CALCI Consortium Responses to Questions on Calibration

June 5, 2020
CALCI Scope Review Workshop

Responses to Committee Questions

Kapton Simulation Results

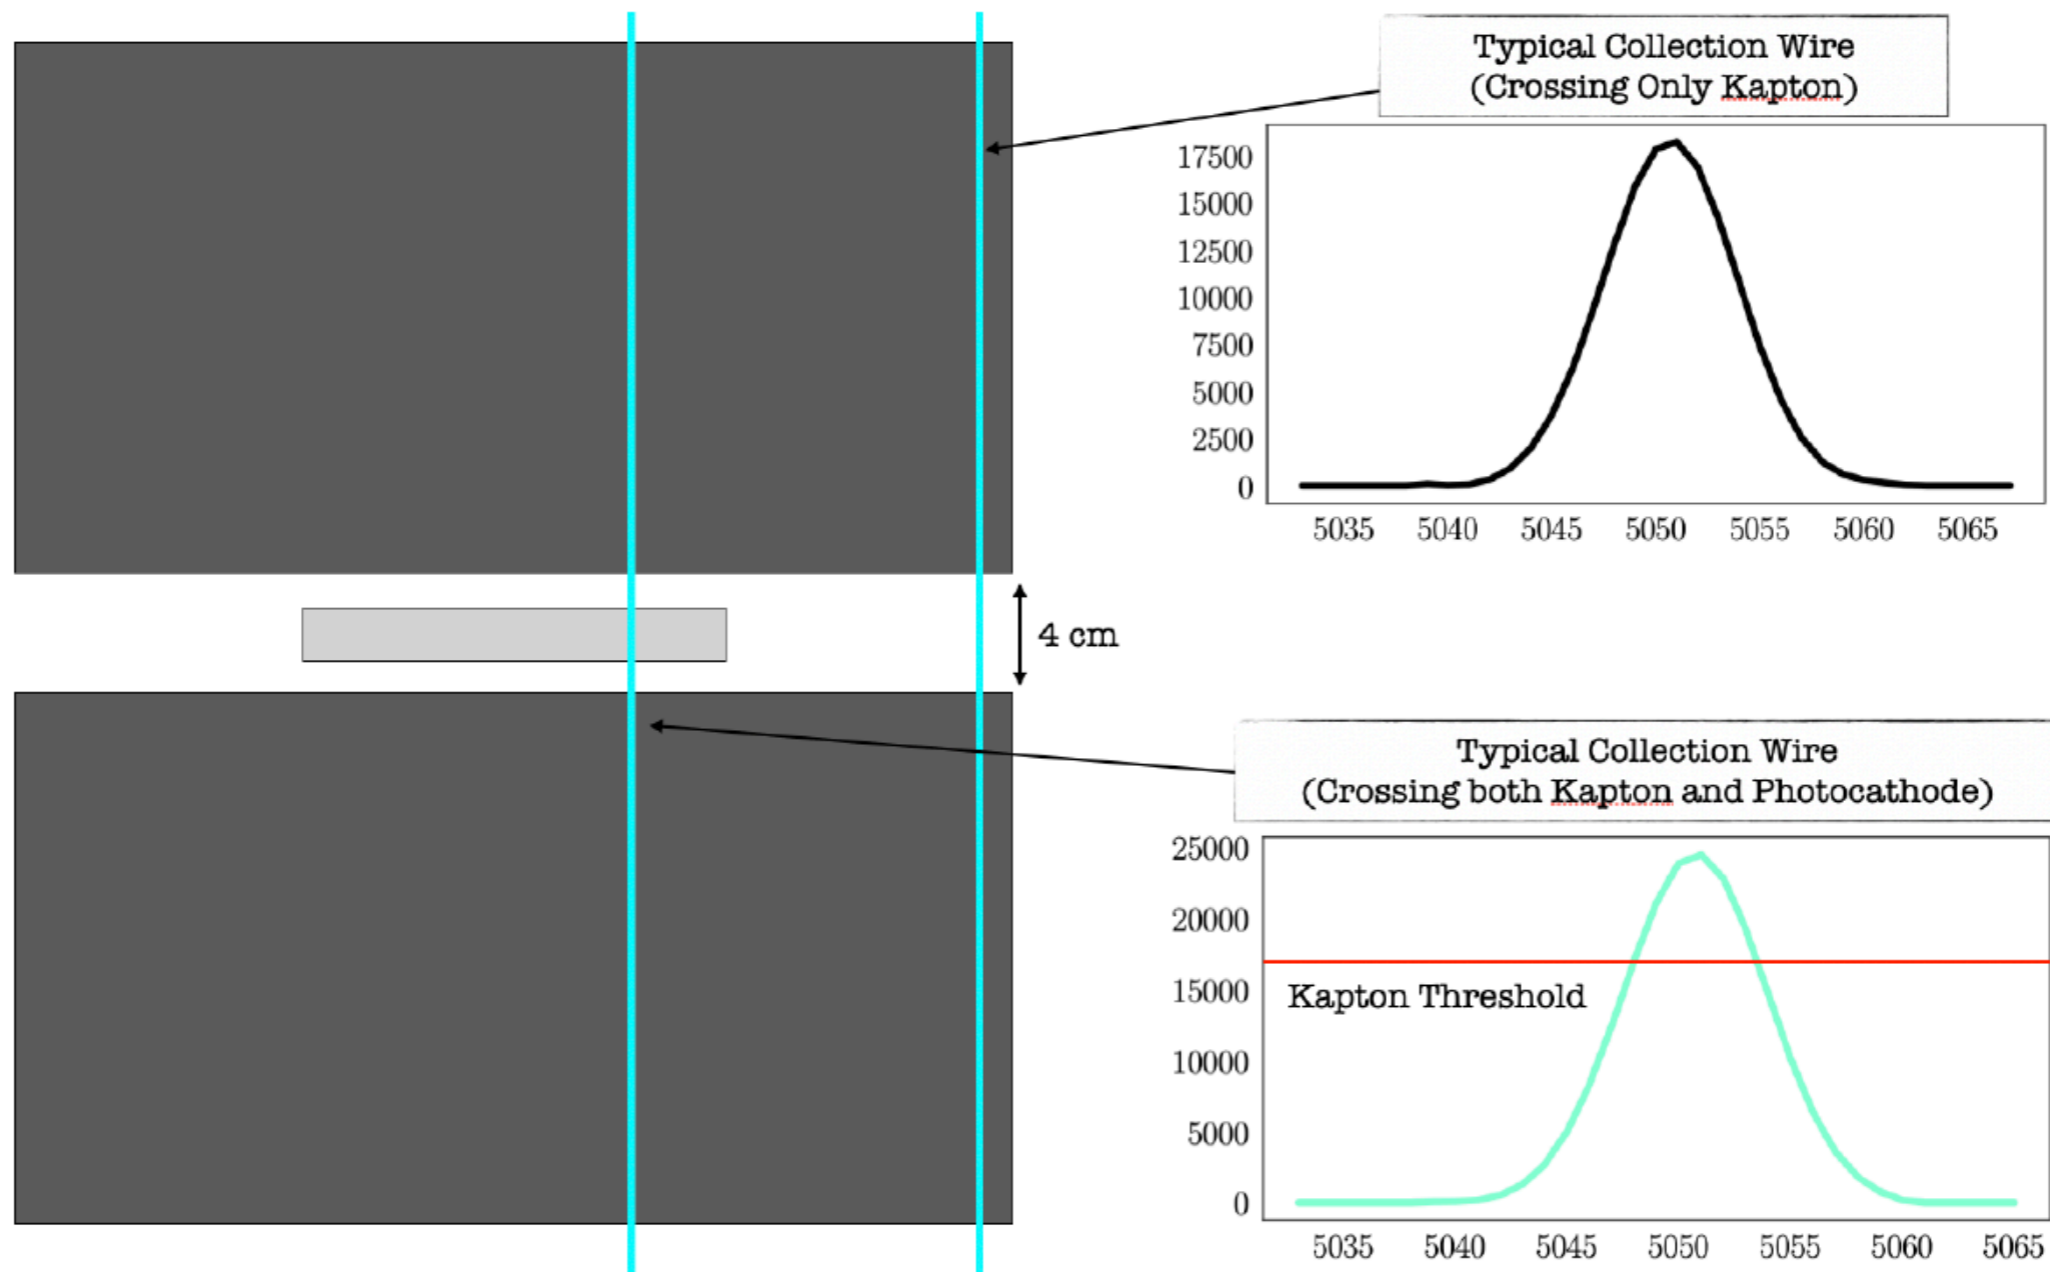
Q5. On slide 20 of Jelena's presentation, it indicates that a 5m illumination diameter is anticipated. Is this from a single fiber? This would be about the correct size to illuminate the entire cathode plane surface parallel to a single APA. Should we be concerned that the resulting emission of electrons from all of the targets and brass connectors will produce a signal in every readout channel of the APA making it impossible to identify the electrons associated with specific targets? For a diameter this large, how non-uniform is the light over the illuminated area and does the non-uniformity remain consistent pulse to pulse?

Typical collection wire signal crossing Kapton strip peaks at ~24,000 (arb. units), while Collection wires that do not cross Kapton peak at ~18,000 (arb. units).

Thus, Kapton related background will be removed with threshold cut.

Opening angle from spec. =22 deg

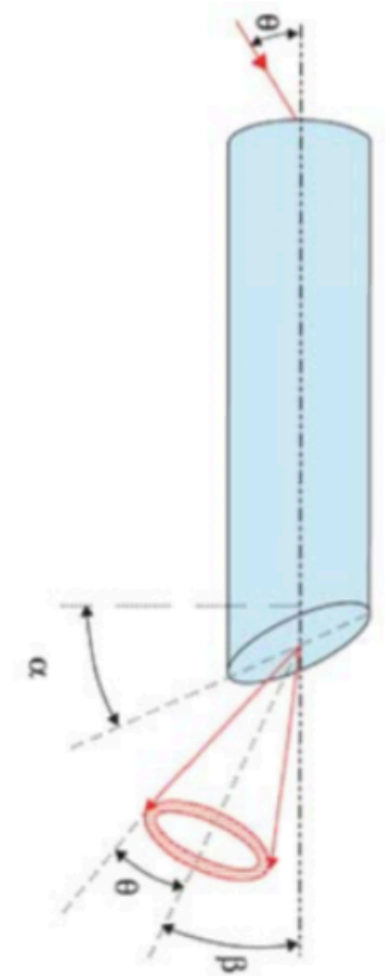
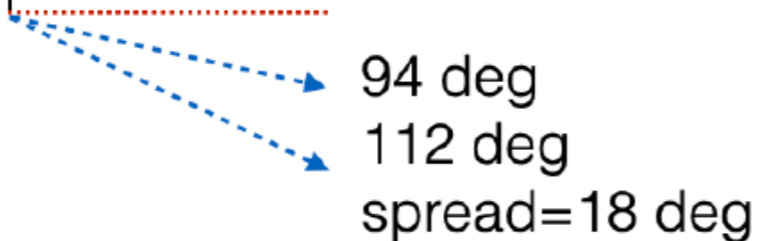
Q6. What is the range of opening angles for the Polymicro quartz fibers? How small of an illumination diameter is possible including the effects of diffusion in the liquid argon?

- The angle of divergence (opening angle) θ is 25.4° deg in air and 20.6° in LAr.
- It is equal to the angle that the traveling light makes with the axis of the beam, so it cannot be varied by more than a few degrees as can be seen in the picture.
- The pointing angle (β) depends on the angle (α) at which the “distal” end is cut. We can thus illuminate entire length of CPA from fibers at the top of APA.
- There is enough space between the APA and we can modify the holder to accommodate more fibers.

- Photo of the preliminary test to check the angular light output as claimed by the manufacturer.
- Accurate tests of light intensity and spread will use better light injection, not a handheld laser pointer like in the photo.
- In addition to subpar injection the phone camera sensor response also played into the image shown.
- The measurement setup will include a light sensor with powermeter that can be moved in x-y direction on the screen to characterize light pattern.
- In order to accurately orient fiber, we will use a fabricated holder which is in the works.

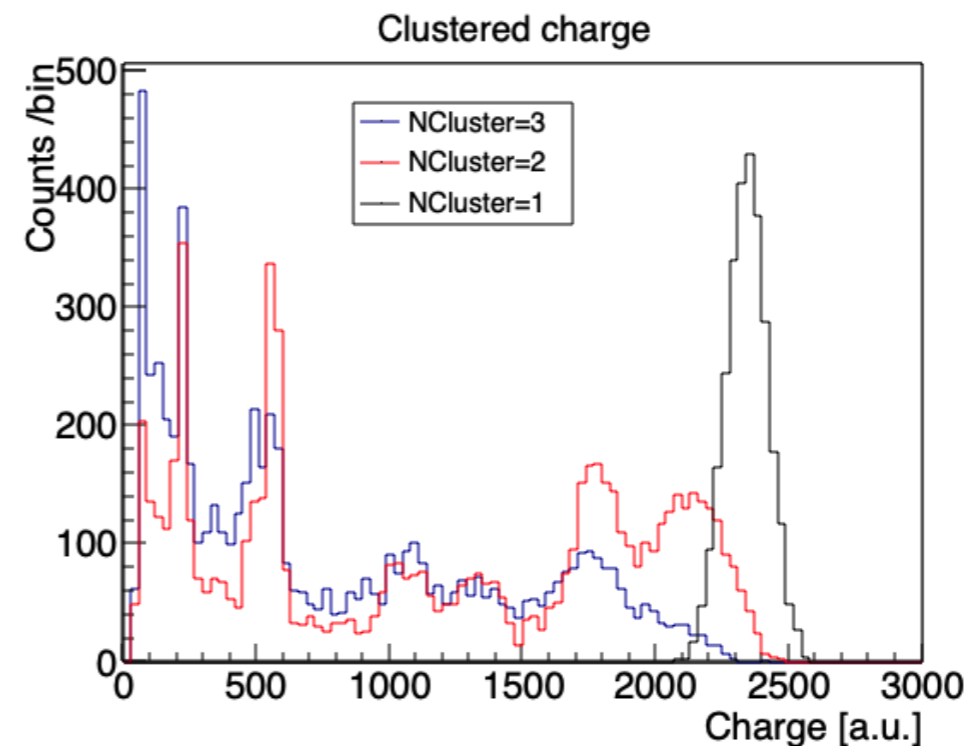
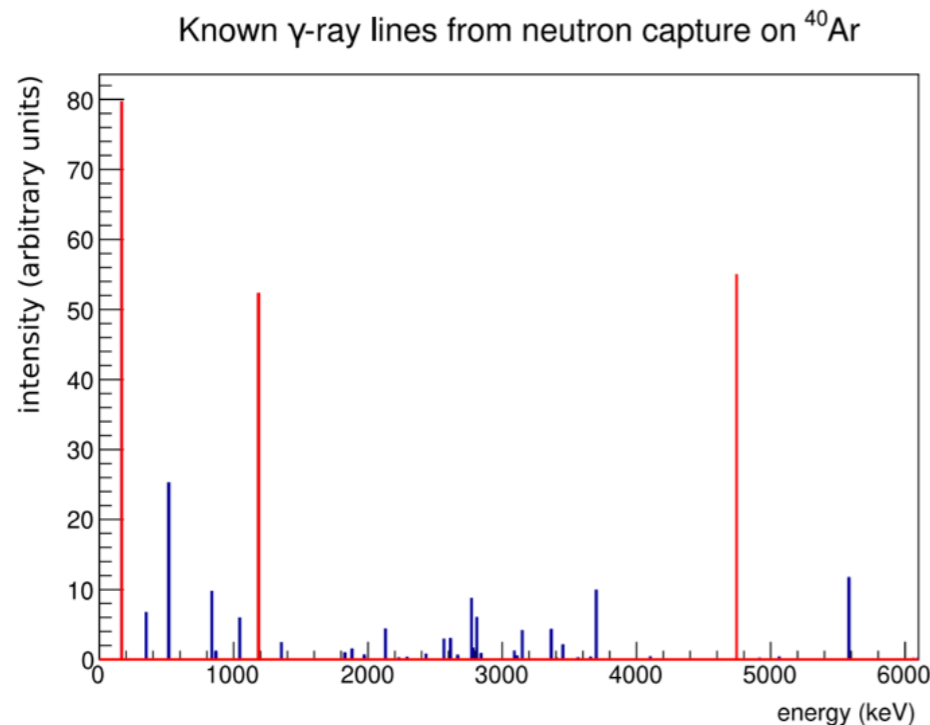
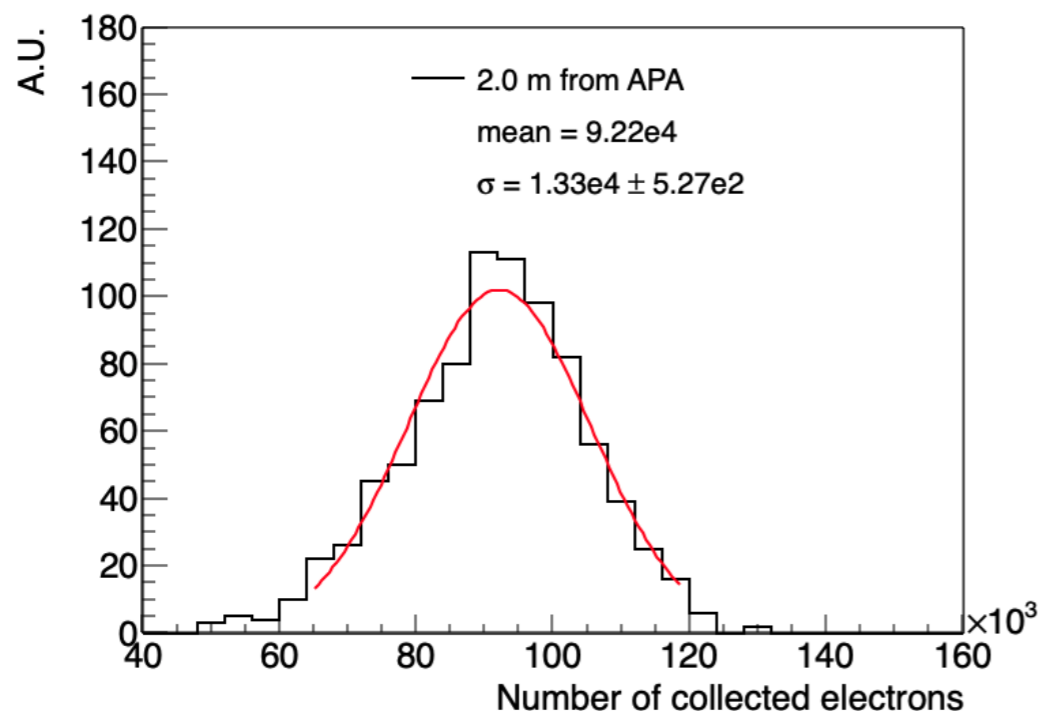
Q1. Are there simulation studies that show the energies from all gamma cascade daughters produced by the neutron capture in Argon are in fact detectable (e.g. a few hundred KeV photons undergoing Compton scattering will produce electrons with energies less than 100 KeV)?

- The reconstruction of each individual gamma is not necessarily needed for calibration, but could improve the data selection. Geant4 simulation has shown that the clustering method can reveal the characteristic energy lines of individual gammas, which can help suppress the background and select pure neutron capture samples. The clustering algorithm will be verified using full LArSoft reconstruction procedures.

- 100 keV energy deposition can produce about 2000 drift electrons, which is well above the Equivalent Noise Charge (ENC~500). The energy deposition below 100 keV may not be detectable due to threshold effect.
- 6.1 MeV total energy deposition can produce $\sim 10^5$ drift electrons. If we use a threshold of $5 \cdot \text{ENC}$, the contribution from the noise fluctuation to the reconstructed gammas is about $\sim 2.5\%$. Standard
- LArsoft simulation and reconstruction has shown that we expect to get $\sim 1e5$ collected electrons for a 6.1 MeV gamma cascade. We will use simulation and test data to understand the threshold effect.

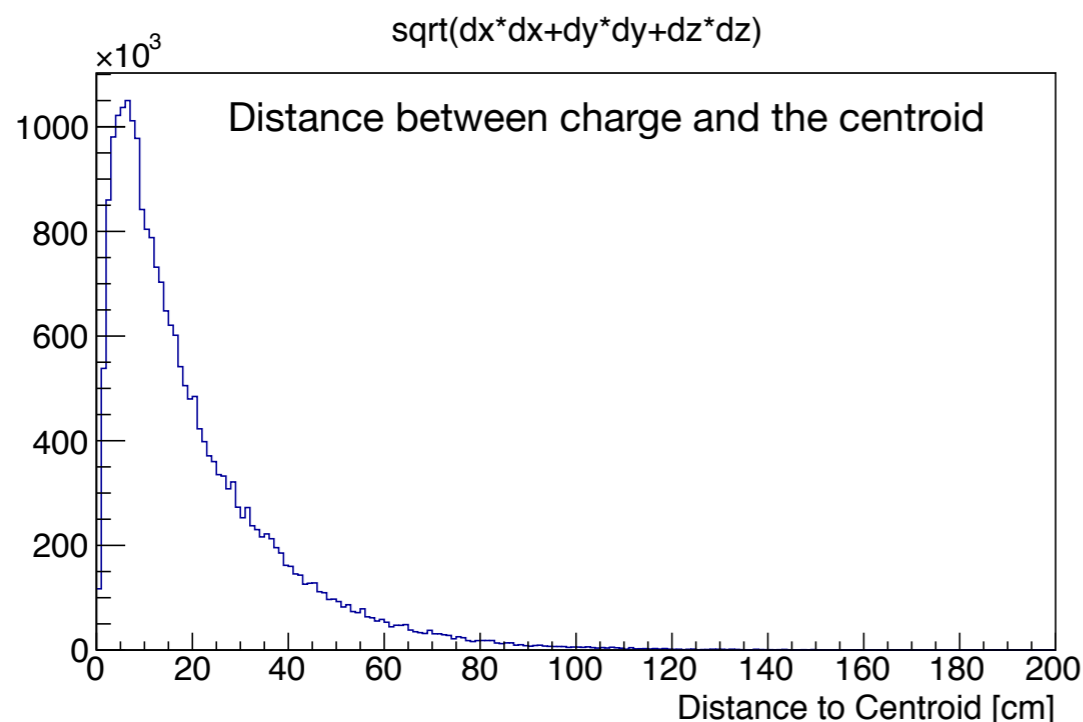
Q2. Are the cascade decays from the gamma close enough in time such that a single t_0 obtained from the photon detection system is sufficient for reconstructing the decay products? Does overlap of neutron capture events or the rate of background Ar39 decays in the far detector lead to difficulties in assigning a correct t_0 to each neutron capture?

- The gammas from neutron capture are emitted within picoseconds of each other, and since the distances traveled before Compton scattering range from 5 cm at 100 keV to 20 cm at 5 MeV (implying a time delay of less than 1 ns) there is no issue with gamma emission times.
- ^{39}Ar decays with a single electron with an endpoint energy of 565 keV. The activity in liquid argon made from argon extracted from the air is about 1 Bq/kg. The chance of seeing an ^{39}Ar decay within the neutron capture event is 18%, but this can be corrected based on our knowledge of ^{39}Ar decay rates and energy deposition.

Geant4 Simulation of neutron capture shows the distance of the charge from the centroid of the charge for each event. 90% of the charge is absorbed within 45 cm of the centroid.
